**FINDINGS AND RECOMMENDATION
OFFICE OF PLANNING AND ZONING
ANNE ARUNDEL COUNTY, MARYLAND**

CASE NUMBER: 2025-0031-V

The applicant is requesting a variance to allow dwelling additions (sitting room, plant room, deck, screened porch, kitchen and bedroom expansion) with less setbacks than required and with disturbance to slopes of 15% or greater on property located at 614 Echo Cove Drive in Crownsville.

VARIANCE PLAN
SUNRISE BEACH ~ LOT 756 & P/O 755
614 ECHO COVE DRIVE, CROWNSVILLE, MD 21032
TAX ACCT. NO 02-748-06569760
TAX MAP 0031 GRID 0008 PARCEL 0142 DISTRICT 2ND
ANNE ARUNDEL COUNTY, MARYLAND

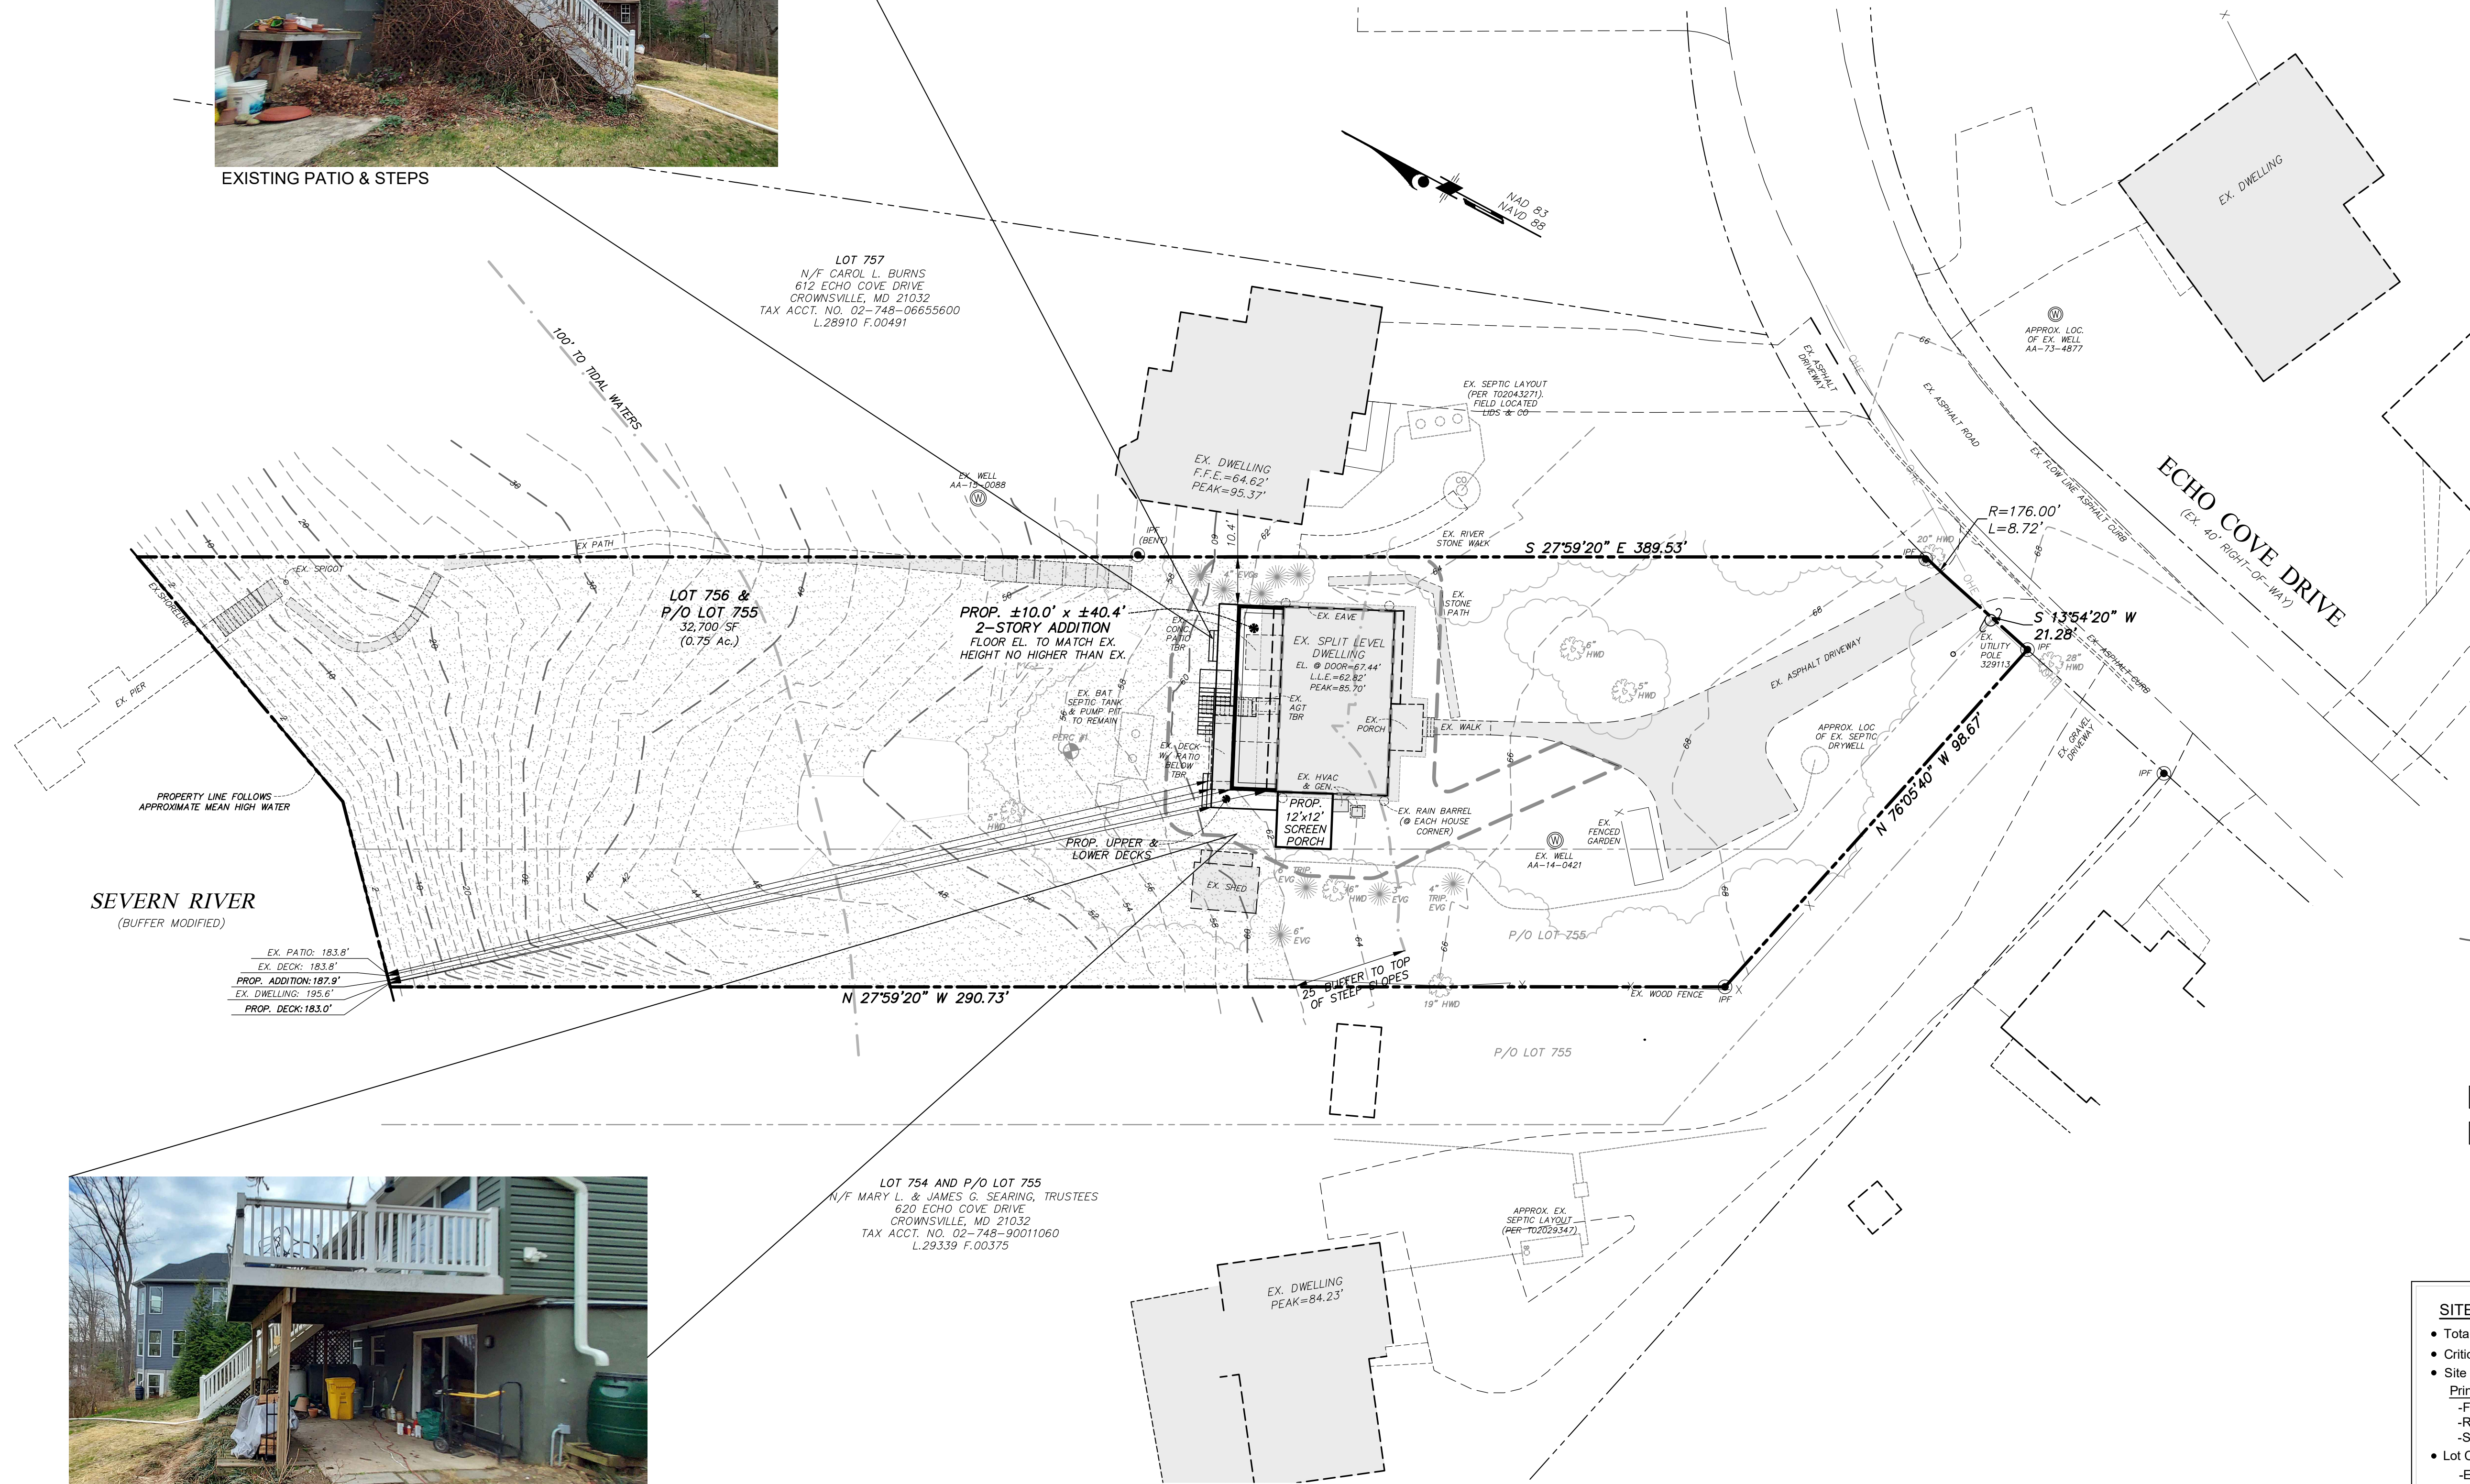
The proposed construction will disturb slopes of 15% or greater, necessitating a variance. The final amount of disturbance will be determined during permit review.

In this particular case, the area of the property on the waterfront side of the dwelling is encumbered by steep slopes making redevelopment there difficult, but not impossible. As proposed, it appears that the majority of the two-story addition will be outside of the steep slopes, while the majority of the proposed multi-level deck will be within the steep slopes. Slightly reducing the size of the addition, and eliminating or relocating the deck to the west side of the dwelling would avoid permanent disturbance to the steep slopes, and reduce the overall relief being requested, as it would only cause temporary disturbance. Alternatively, as suggested in the Pre-file comments, there appears to be ample space to the west and south of the dwelling for additions and deck while avoiding the slopes altogether, thereby eliminating the need for a critical area variance. In either case, a variance would not be required to remove the existing shed, if necessary, from the steep slopes. Although other alternatives may require a reconfiguration of the existing floorplan, and incur additional expense, financial considerations cannot be deemed an exceptional circumstance in granting a variance.

Because there are alternative locations to site the additions, strict implementation of the County's Critical Area program would not result in an unwarranted hardship. A literal interpretation of the program will not deprive the applicant of rights that are commonly enjoyed by other properties in similar areas because no property may disturb steep slopes in the Limited Development Area. As such, the granting of the variance will confer on the applicant special privileges that would be denied by COMAR, Title 27.

However, because alternatives exist which would eliminate or reduce the relief requested, the variance is not considered the minimum necessary to afford relief. As such, this Office cannot support the variance request.

- ***denial*** of a Critical Area variance to § 17-8-201 to disturb steep slopes. If granted, the final amount of disturbance will be determined during permit review.
